NRC-03-108

November 5, 2003

**KEWAUNEE NUCLEAR POWER PLANT
DOCKET 50-305
LICENSE No. DPR-43
RESPONSES TO REQUESTS FOR ADDITIONAL INFORMATION AND
SUPPLEMENTAL INFORMATION REGARDING LICENSE AMENDMENT REQUEST
195, STRETCH POWER UPRATE FOR KEWAUNEE NUCLEAR POWER PLANT**

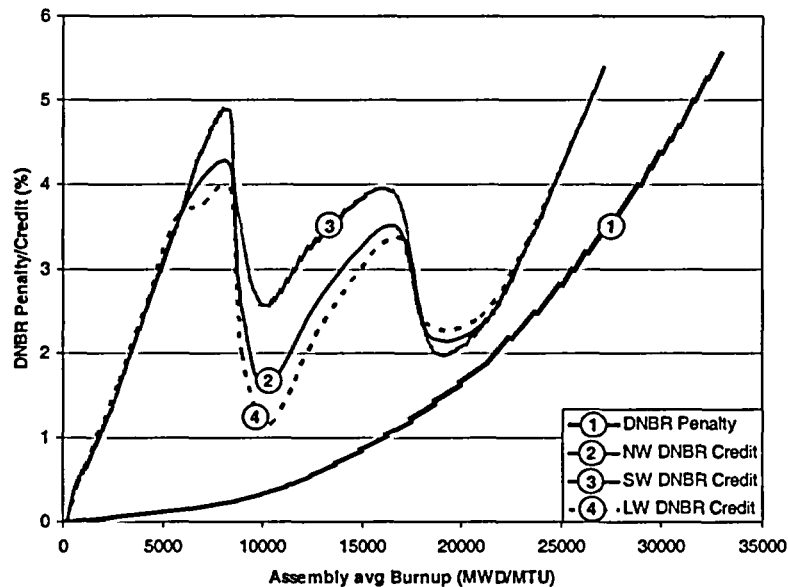
- a. **The RTSR analyses included a 2.6 percent rod bow DNBR penalty. For the stretch uprate, the licensee reduces the rod bow penalty from 2.6 percent to 0 percent for Cycle 26 by evaluating the F H burndown DNBR credit during the entire cycle. Please provide the technical justification for this change in the rod bow penalty. Include descriptions of the F H burndown DNBR credit and the analyses performed to quantify F H burndown DNBR credit, and provide a reference to the NRC-approved methodology applied. Also, provide the results of the analyses which demonstrate that the necessary rod bow penalty is offset by the F H burndown DNBR credit for Cycle 26.**

The 2.6% rod bow DNBR penalty is based on an analysis performed in Refs. 1 and 2 where it was demonstrated that credit for FdH burndown can be used after 24,000 MWD/MTU (assembly average burnup) to limit the rod bow DNBR penalty to 2.6 % for 0.422 OD diameter fuel and WRB-1 DNB correlation. Beyond 24,000 MWD/MTU the rod bow penalty increases beyond 2.6% but it was shown that for a representative set of cycles using Westinghouse fuel, the FdH burndown conservatively offset the additional DNBR penalty and therefore a 2.6% rod bow DNBR penalty is acceptable. This is the general approach that does not require any cycle specific analysis. The method used to evaluate the rod bow DNBR penalty for Kewaunee Cycle 26 was as analogous to the method used for Ref. 1. However, the analysis was performed using the peak FdH as a function of assembly burnup for the specific cycle only (long, normal and short EOC 25 windows). BOL conditions set the reference for the rod bow DNBR penalty (0%) and the FdH burndown credit (0%). The rod bow DNBR penalty increase with assembly average burnup was calculated according to the approved methodology described in Ref. 1. The peak FdH as a function of assembly burnup was calculated by ANC for Kewaunee Cycle 26 (long, normal and short windows). The credit/penalty curves due to FdH variation were calculated based on a conservative one-to-one relation with DNBR (this is much less than the minimum DNBR sensitivity to FdH, which is calculated to be 1.898 for the set of RTDP conditions used in the Design Limit DNBR calculation). The result of the comparison is shown below.

The figure shows that the rod bow DNBR penalty is offset by a conservative FdH burndown credit over the entire life of Kewaunee Cycle 26 core. Therefore the rod bow DNBR penalty was evaluated to be 0% for Kewaunee cycle 26. Please note that even though a similar methodology as the one used in the approved topical report (Ref. 1) was used, since the analysis was performed based on Kewaunee Cycle 26 peak FdH only, this is in non conformance with the current approved methodology and therefore needs a specific approval for use during this cycle.

Kewaunee LONF for Uprate

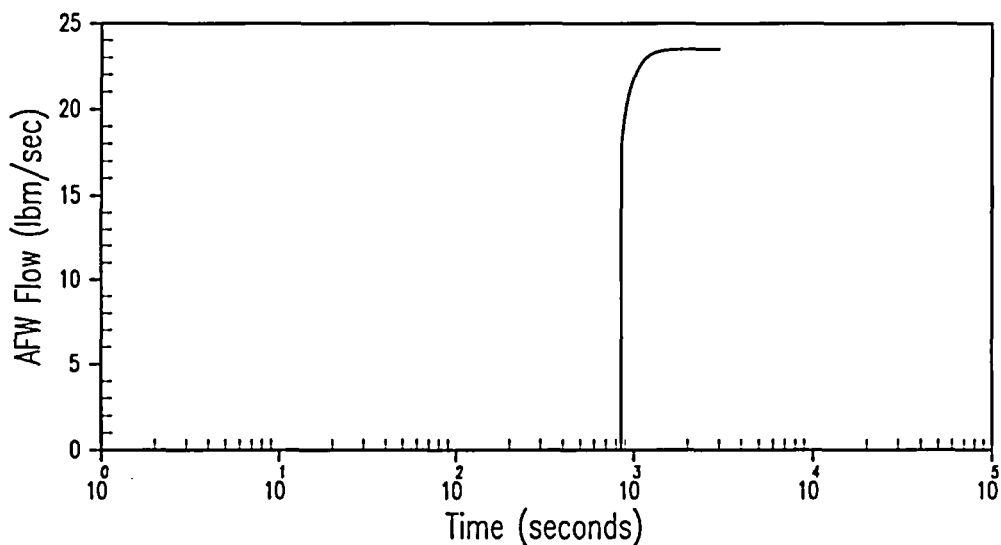
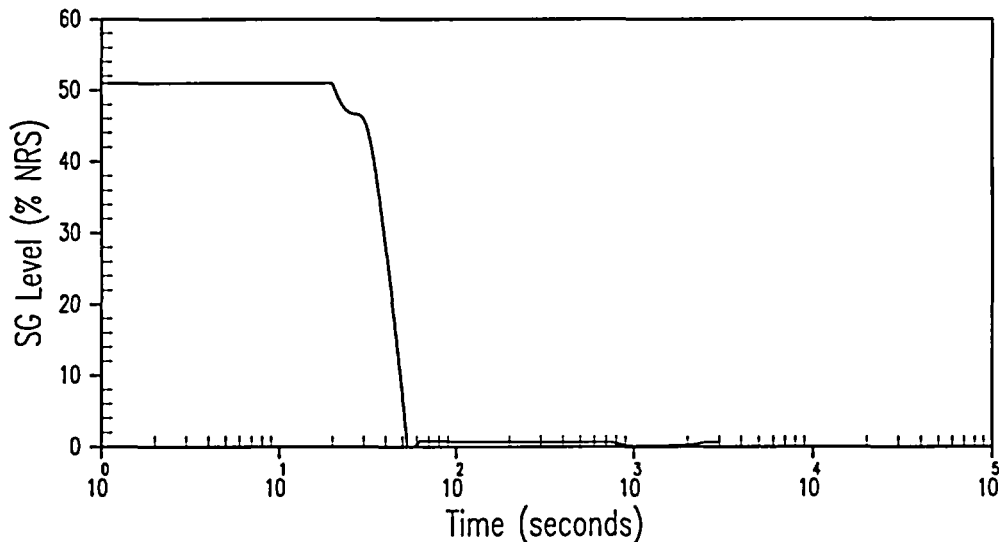
36. To support the results of the loss of normal feedwater transient, please provide the following:
